Department of Energy
Washington, D.C. 20545

Docket No. 50-537
HQ:S:82:065

RESPONSES TO REQUEST FOR ADDITIONAL INFORMATION

Reference: Letter, P. S. Check to J. R. Longenecker, "CRBRP Request for Additional Information," dated April 30, 1982

Figure 5.7-61 Affected Loop Drum Steam Temperature for Loss of Steam Generator Load (Dumping of Water/Steam Sides of Both Evaporators and the Superheater).

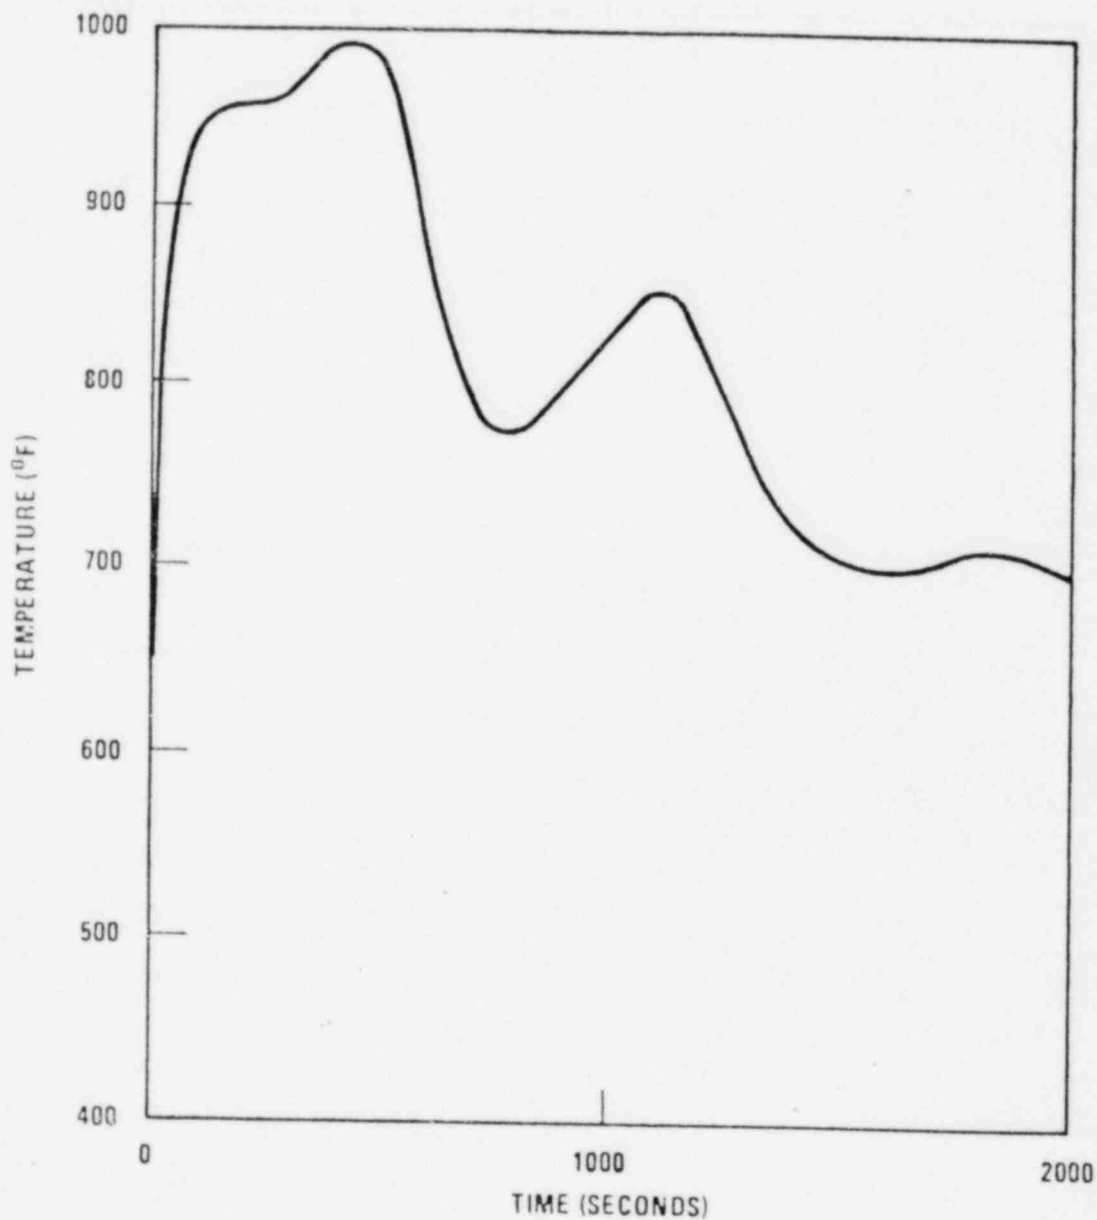
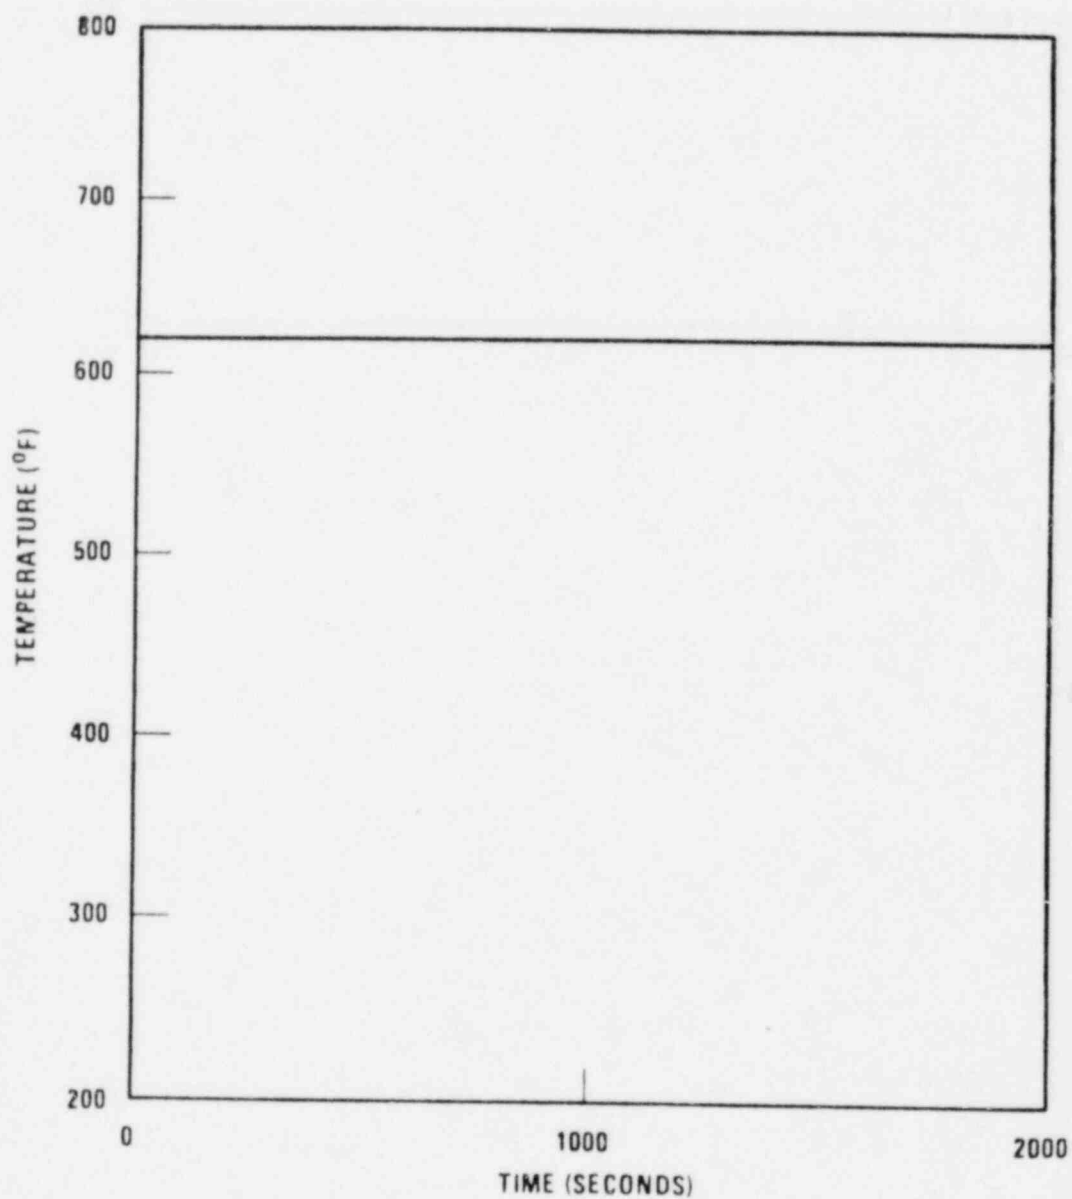
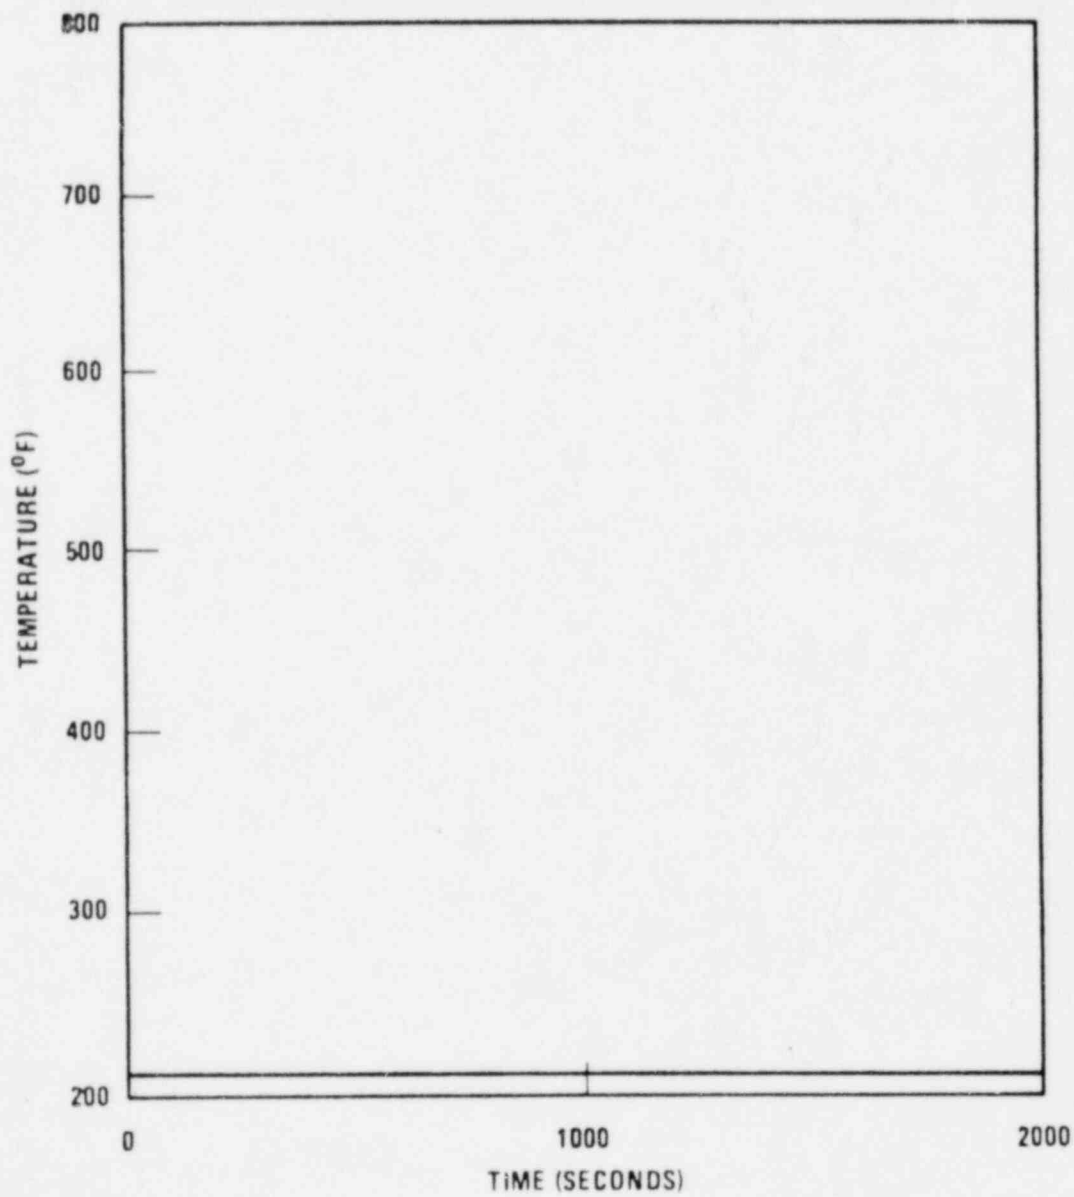
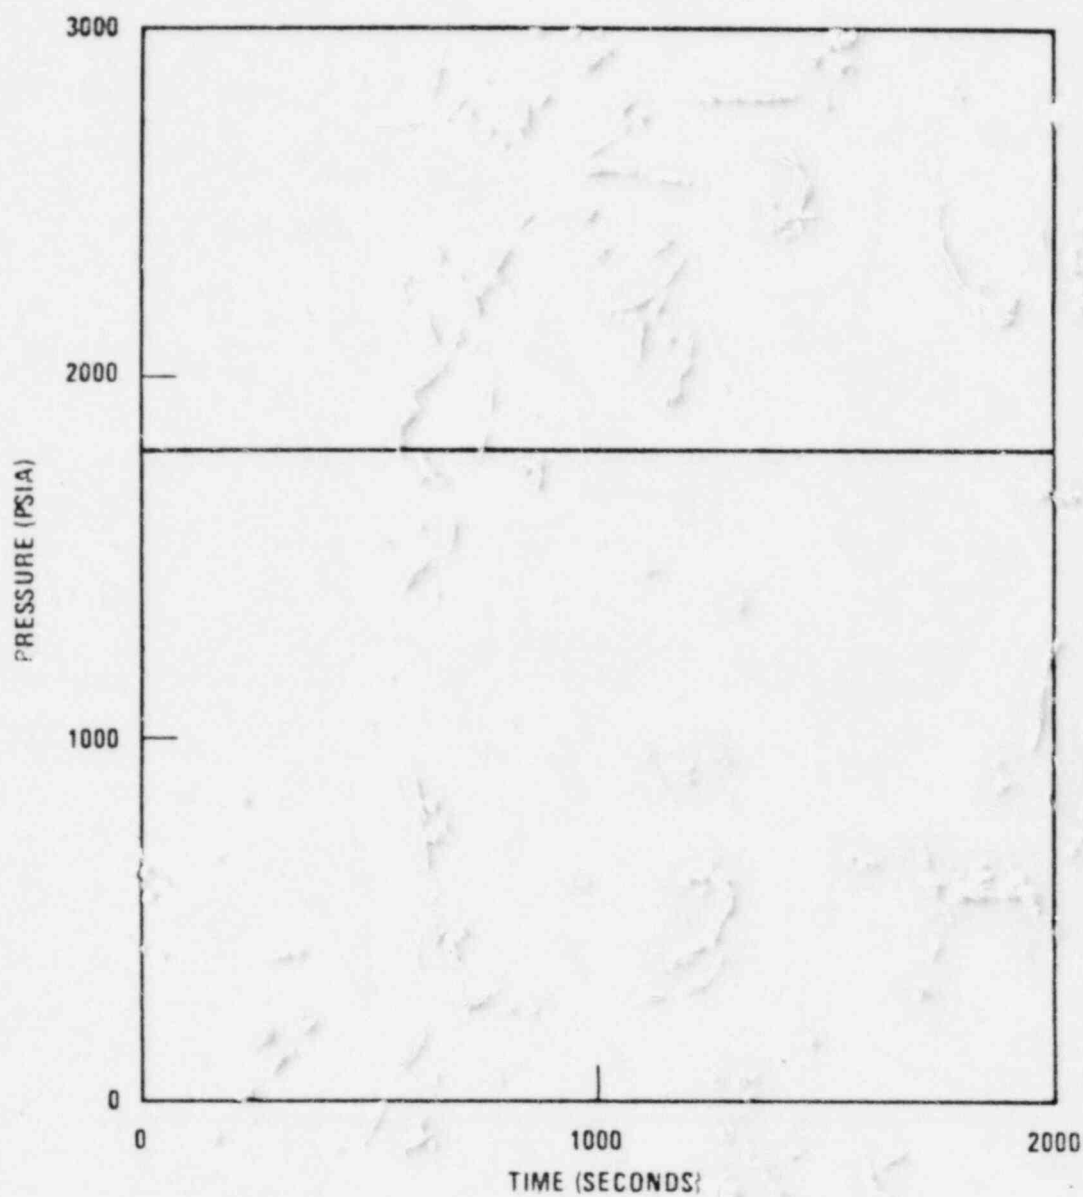
Question CS760.131 Transient Effects (5.7.5)

The steam generator temperature and pressure response and core temperature response is provided in Figures 5.7-6a-k. These data are based on the plant thermal hydraulic design conditions with the hot and cold leg sodium arbitrarily increased 20°F.
